HAY CREEK VALLEY EL PASO COUNTY, COLORADO CONSTRUCTION DOCUMENTS

DECEMBER 2023

PCD FILE #: SF2324
	BENCHMARK PROJECT ELEVATIONS ARE NAVD 88 ELEVATIONS BASED ON AN OPUS DERIVED ELEVATION ON CONTROL POINT 10, A NO. 5 REBAR HAVING AN ELEVATION OF 5769.92.		SEAL	HAY CREEK VALLEY
			PRELIMINARY THIS DRAWING HAS NOT BEEN APPROVED BY	EL PASO COUNTY, COLORADO CONSTRUCTION DOCUMENTS
, ү 	BASIS OF BEARING THE SOUTH LINE OF THE NORTHWEST QUARTER OF SECTION 22, TOWNSHIP 15 SOUTH, RANGE 65 WEST OF THE 6TH PRINCIPAL MERIDIAN, COUNTY OF EL PASO, STATE OF COLORADO, BEING MONUMENTED ON THE EASTERLY END BY A 2-12" ALUMINUM CAP STAMPED "NOLTE PLS25955 C1/4 S22 T15S, R65W 1999, "AND THE WESTERLY END BY	PREPARED BY: Matrix	GOVERNING AGENCIES AND IS SUBJECT TO CHANGE	TITLE SHEET
	A2-1/2" ALUMINUM CAP STAMPED "SSS PLS 16154 1/4 S21 S22 T15S, R65W 2000, "BEING ASSUMED TO BEAR S89°54'42"W, A DISTANCE OF 2,627.78 FEET.	Excellence by Design	FOR AND ON BEHALF OF MATRIX DESIGN GROUP, INC. PROJECT No. 22.886.076	DESIGNED BY:JAOSCALEDATE ISSUED:DECEMBER 2023DRAWING No.DRAWN BY:CVWHORIZ.N/ASHEET01OF 26TSO1CHECKED BY:JAOVERT.N/ASHEET01OF 26TSO1

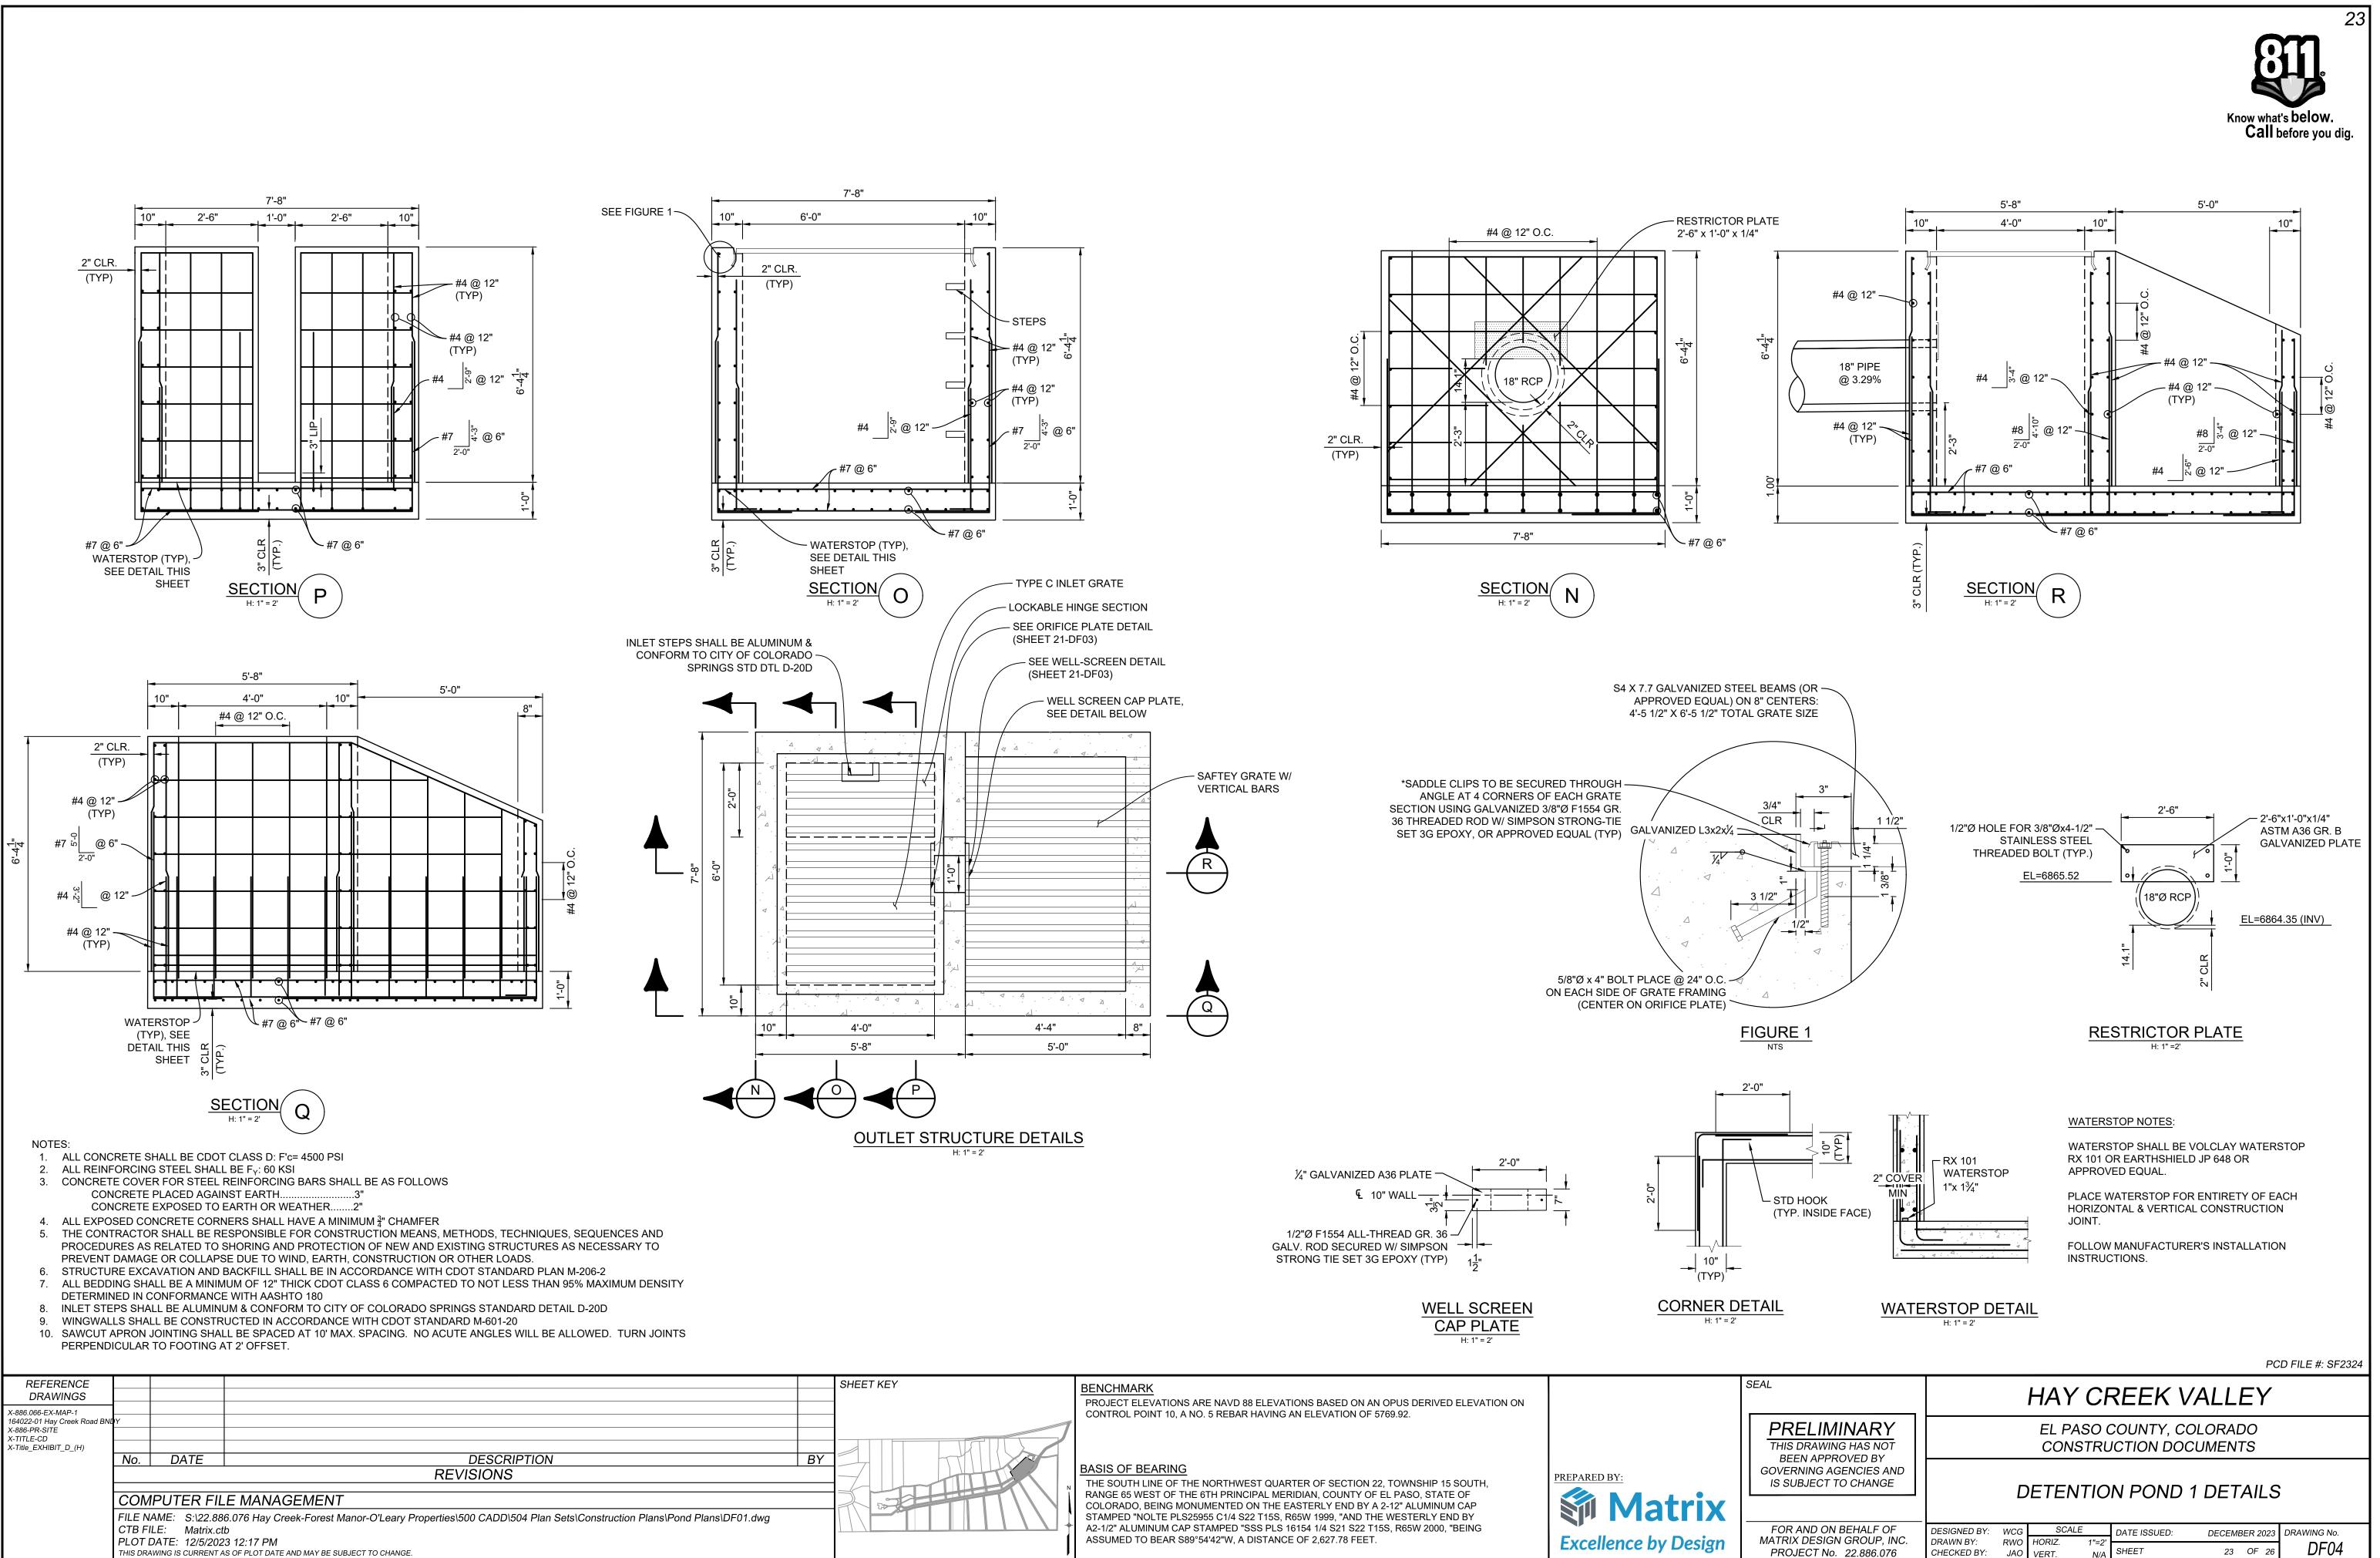
According to the MHFD-Detention spreadsheet on PDF pg 44 of the FDR, this centroid elevation is supposed to be at Stage = Oft which should be at the top of the WSEL of the micropool, which is at 6864.60ft

Comment generated due to changes in the document from previous submittal.
